# Team Update 03

- **Game Data Details:** The [2018 Game Data Details](#) article has been updated with additional information about initial states and to match the game updates below.
- **Drawing Updates:** [The Layout and Marking Diagram](#) has been updated with the following changes:
  - FE-00041-02 has been added.
  - FE-00041-03 has been added.
- **3D CAD Models Updates:** Field Graphics have been added to the [CAD Models](#) download.

Figure 3-4: The SCALE (Note, cable protectors are shown, but are not part of the SCALE)

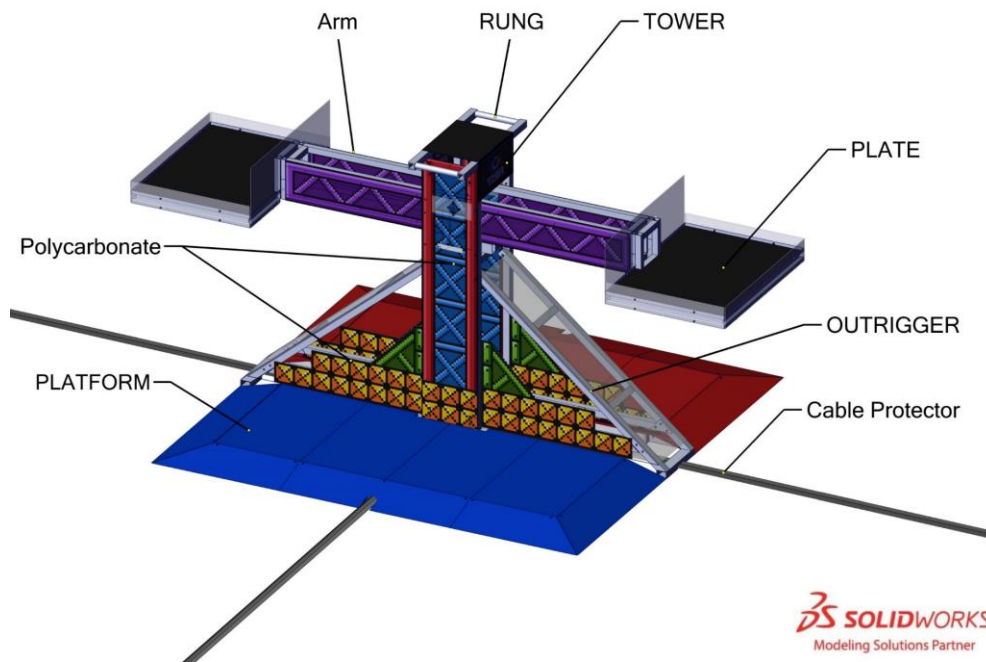
The BRICKS are graphics depicting golden squares surrounded by a black outline that extends 12 in. (~30cm) above the **horizontal** surface of the PLATFORM.

Figure 3-11: PLATFORM top length and width dimensions

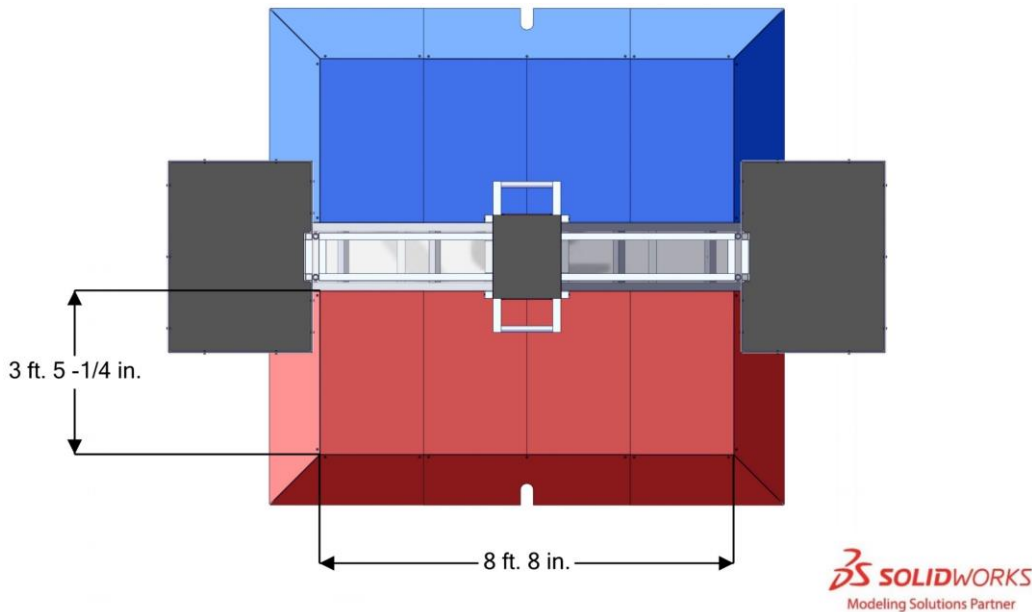
Located at the base of the SCALE, on each side, is a PLATFORM covered with ALLIANCE colored HDPE. The TOWER and OUTRIGGERS separate one PLATFORM from the other. Each PLATFORM top is 8 ft. 8 in. (~264 cm) wide by 3 ft. 5 ¼ in. (~105 cm) deep and 3 ½ in. (~9 cm) tall. The ramps leading to the PLATFORM includes ramps with a run of 1 ft. 4 ¾ in. (~33 32 cm) and long with a 15.35 deg. angle. The ALLIANCE colored tape that abuts the PLATFORM ramps is part of the PLATFORM.

Figure 4-1 Possible PLATE assignments

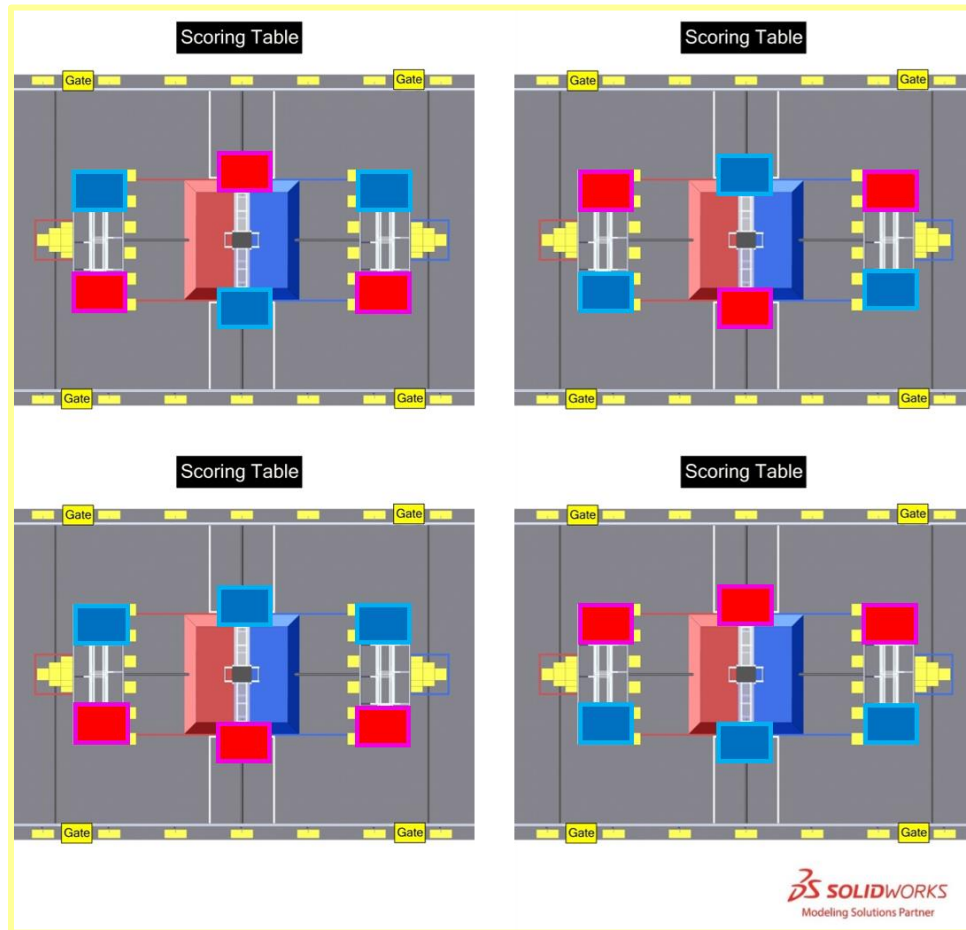
Each MATCH is divided in to two stages. The first stage, called Autonomous (AUTO), is the first fifteen (0:15) seconds of a MATCH in which ROBOTS operate without any DRIVE TEAM control or input. Prior to the start of AUTO, the assignments of ALLIANCE colors for SWITCH and SCALE

PLATES are randomized among the four states in Figure 4-1 and transmitted to the OPERATOR CONSOLE by the Field Management System (FMS). During AUTO, ROBOTS attempt to deliver preloaded POWER CUBES to PLATES, retrieve additional POWER CUBES from around the FIELD, and cross their AUTO LINE any time before the end of the stage.
